Re: **240 Sidney Street -- Special Permit #278**

Re: CPP Preliminary Opinion - Air Quality Effects of 130 Waverly Avenue Lab on 240 Sidney Street

Subject: 240 Sidney Street Residential Development
Impact of Community Noise on Building
Acentech Project No. 623842

Re: Proposed Development of 240 Sidney Street, 40 Allston Street and 618 Grove Avenue
(the “Property”)

Figure 1
240 Sidney Street Residential Development
Sound Level Measurements
Measured 7/30/13

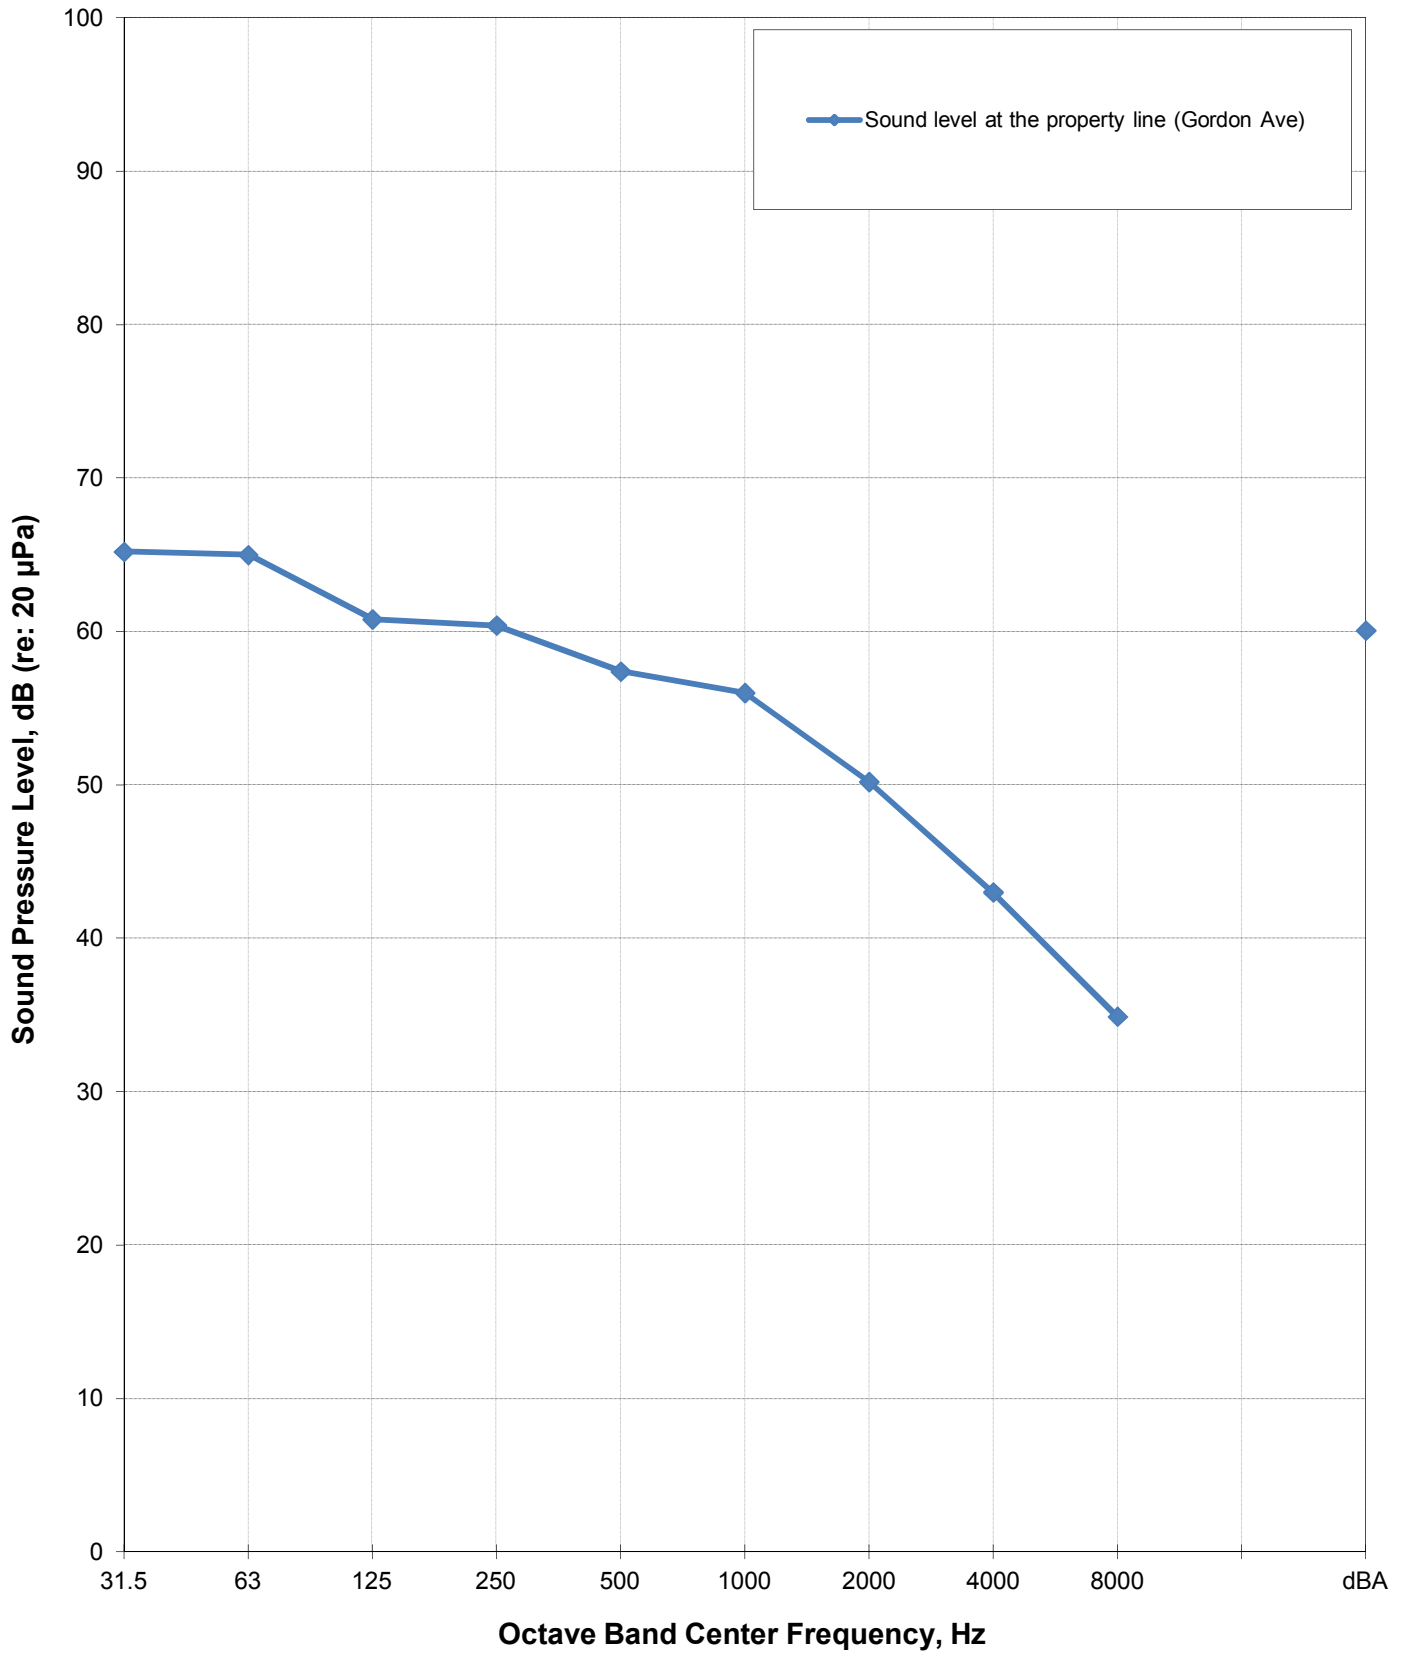
We measured the present noise level at your property line at Grove Avenue to be 60 dBA as presented in Figure 1. The measurement location for this data is shown in the attached Site Diagram. However, this noise level includes noise from several pieces of existing equipment related to the existing buildings at 240 Sidney Street which would be removed when the property is redeveloped. As a result, we also made a measurement at a location halfway between the 40 Erie fans and the 240 Sidney property line, where the dominant noise seemed to be from the 40 Erie fans. This noise level was 62 dBA. This measurement is presented in Figure 2 and the location is shown in the Site Diagram. At this location there was only minor contribution of noise from the existing 240 Sidney equipment. If we account for the fact that some of this noise is from the existing 240 Sidney equipment and extrapolate the noise to the 240 Sidney property line, the estimated noise at the 240 Sidney property line due to the 40 Erie exhaust fans is on the order of 55 dBA. This is not a precise level, but an estimate, since we cannot make more precise measurements of the noise due to the 40 Erie equipment alone.

The noise level due to the 40 Erie equipment meets the current, 65 dBA, commercial use noise requirement in Cambridge. This also meets the 60 dBA daytime noise requirement for residential properties in Cambridge. However, 40 Erie's current exhaust fan noise does not meet the 50 dBA nighttime noise limit in Cambridge for residential properties. 40 Erie's exhaust fan noise, at approximately 55 dBA, is somewhat higher than the nighttime residential requirement once you redevelop the 240 Sidney Street property for residential use.

Figure 2
240 Sidney Street Residential Development
Sound Level Measurements
Measured 7/30/13

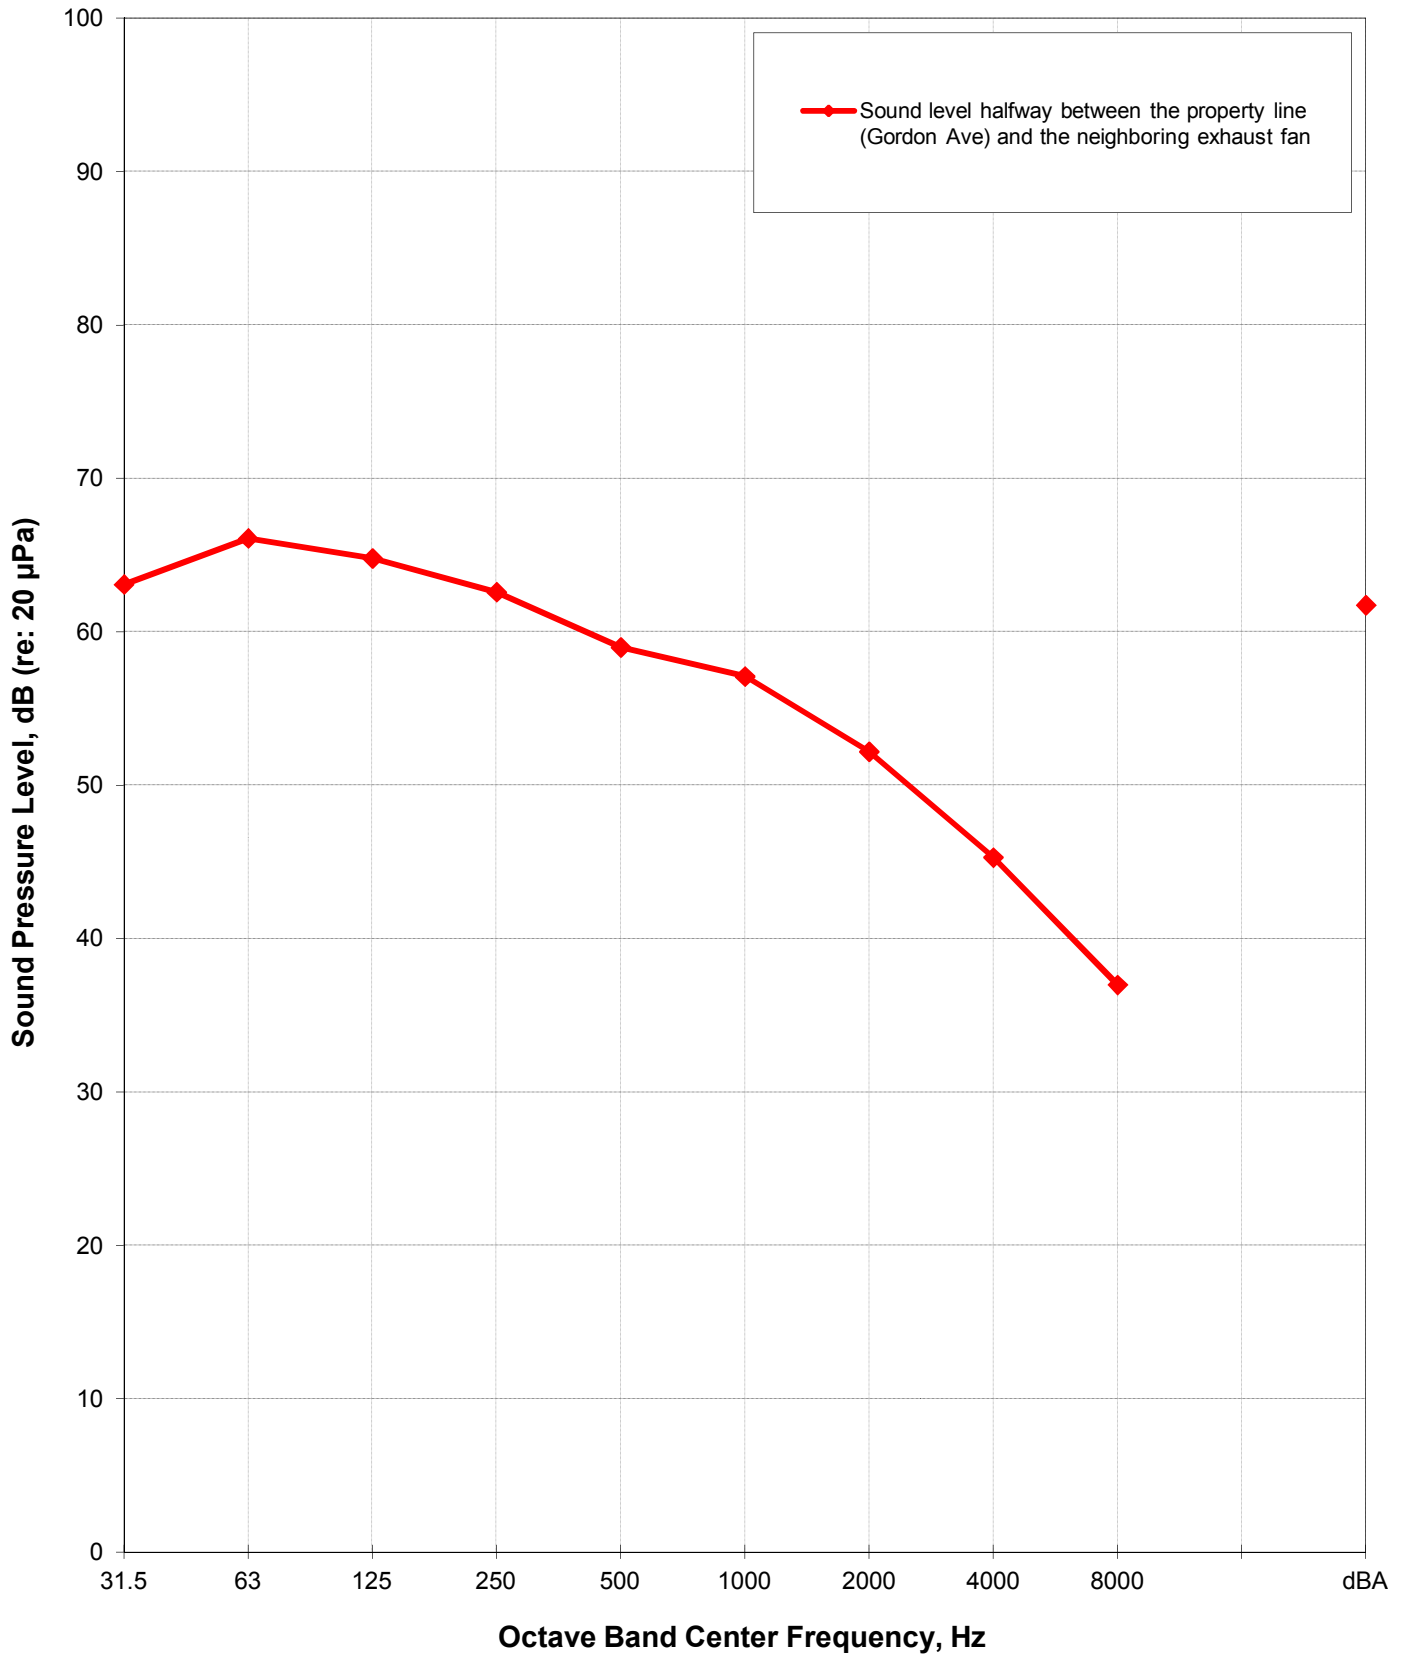
Measurement halfway between property line and neighboring property (Figure 2)
